From: [Kaylee Carr](#)
To: [Robinson, James](#)
Cc: [Nicole Parks](#); [Alissa Salmore](#)
Subject: RE: 21860 - US-91, Park Lawn to Siphon Road - Sole Source Aquifer Checklist
Date: Friday, April 26, 2024 10:42:39 AM
Attachments: [21860 SSA Checklist 04262024.pdf](#)

Subject: 21860 - US-91, Park Lawn to Siphon Road - Sole Source Aquifer Checklist

Sole Source Aquifer Checklist

RETENTION POND DETAIL
US-91, PARK LAWN AVE TO SIPHON ROAD CHUBBUCK

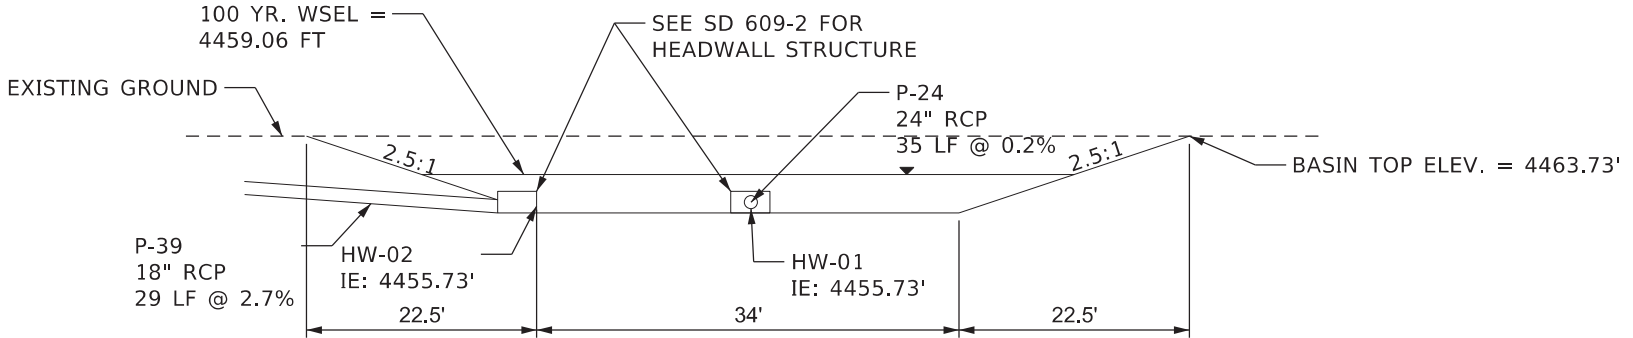
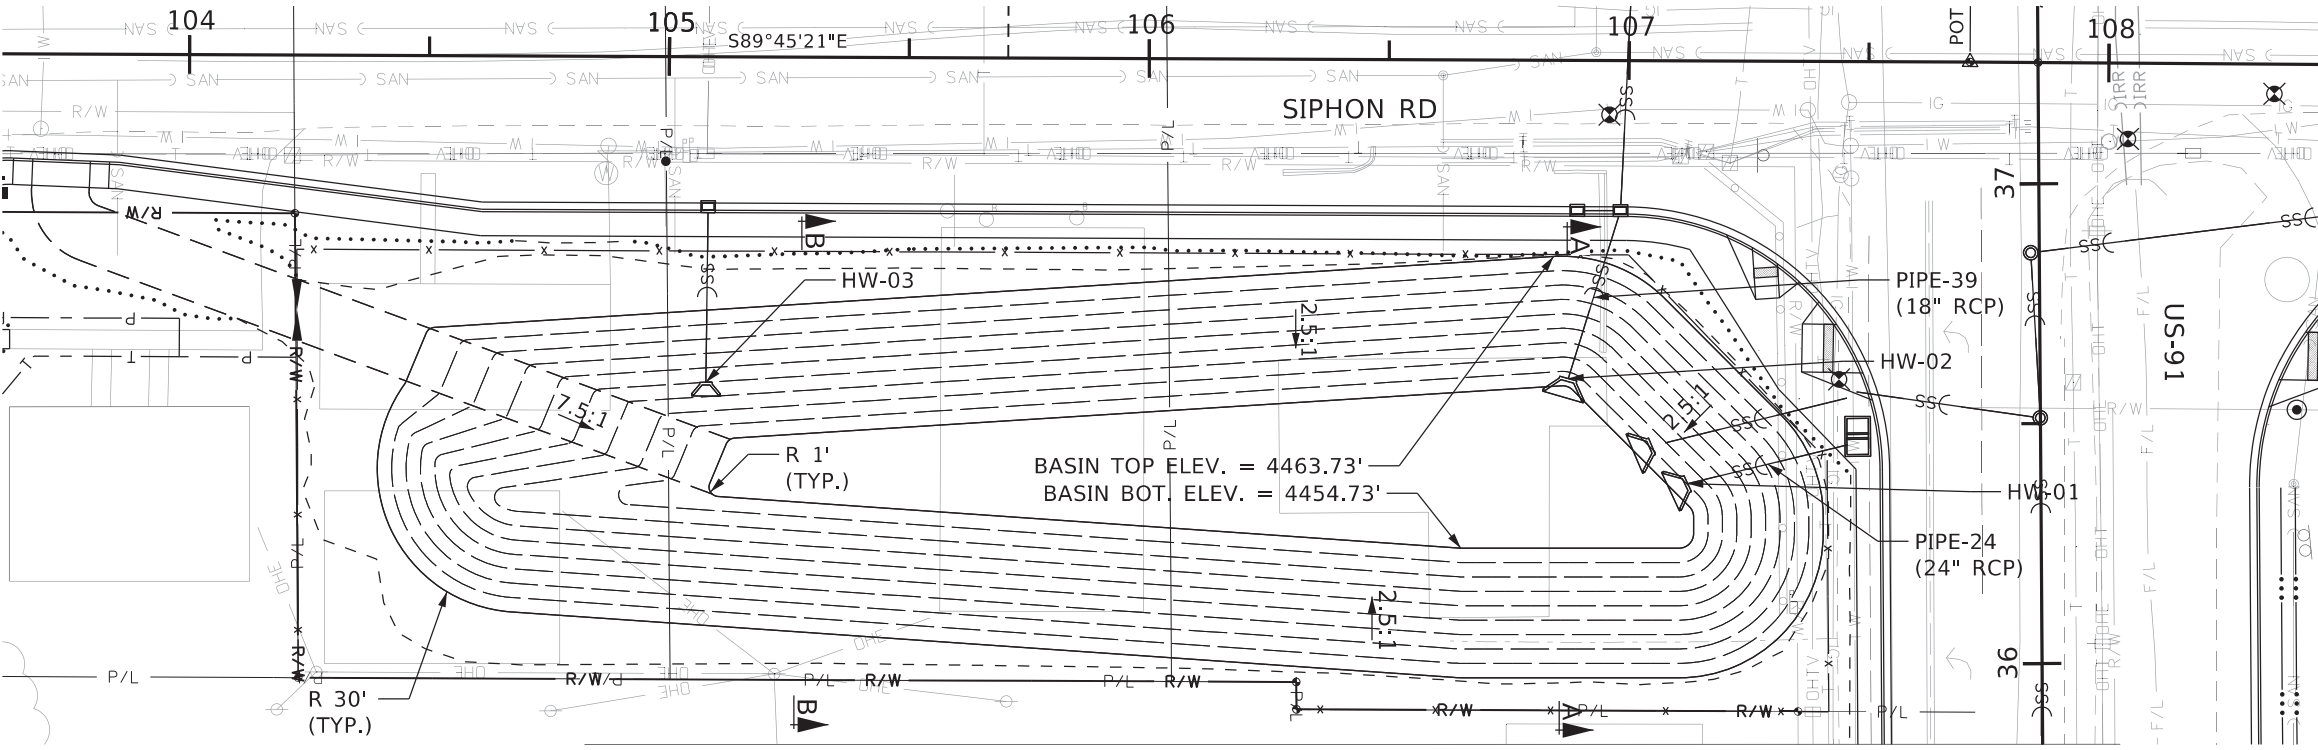
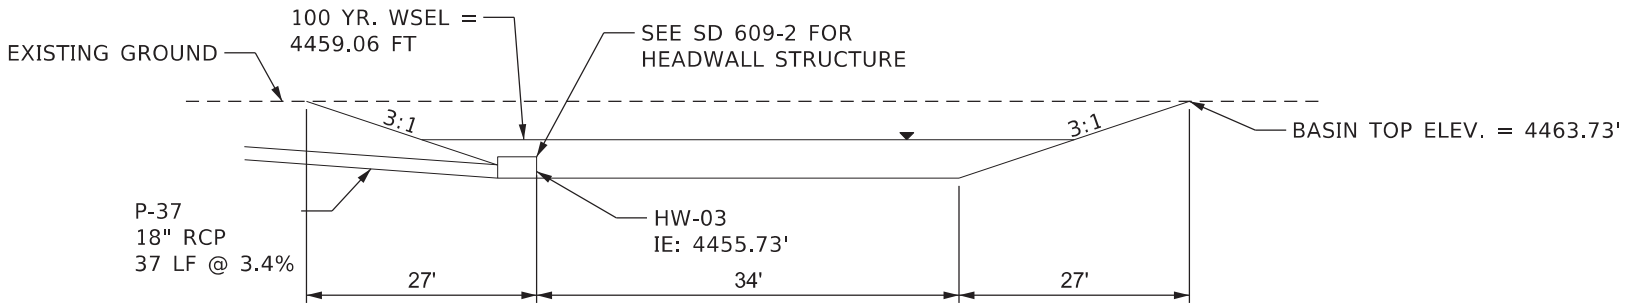
information on the locations of the LUST sites? Are any plans/mitigation measures in place in the event that contamination is discovered during construction? Please also include a figure/plan set of the proposed design showing the approximate locations of the proposed retention basin and associated piping, and road/sidewalk improvements.

I have attached a revised Sole Source Aquifer checklist to address all your questions. Both LUST sites are to the south of the project area (900 and 1400 feet away). If contamination is encountered during construction, IDEQ should be notified. However, the probability of risk associated with construction in the area is low. Additionally, the hazardous materials memorandum has been attached to the updated checklist. Supporting documentation from the public records request is available upon request. A plan set detailing drainage and road/sidewalk improvements has been attached to the checklist as well.

100-YR VOLUME REQUIRED = 0.94 AC-FT
100-YR VOLUME PROVIDED = 2.81 AC-FT
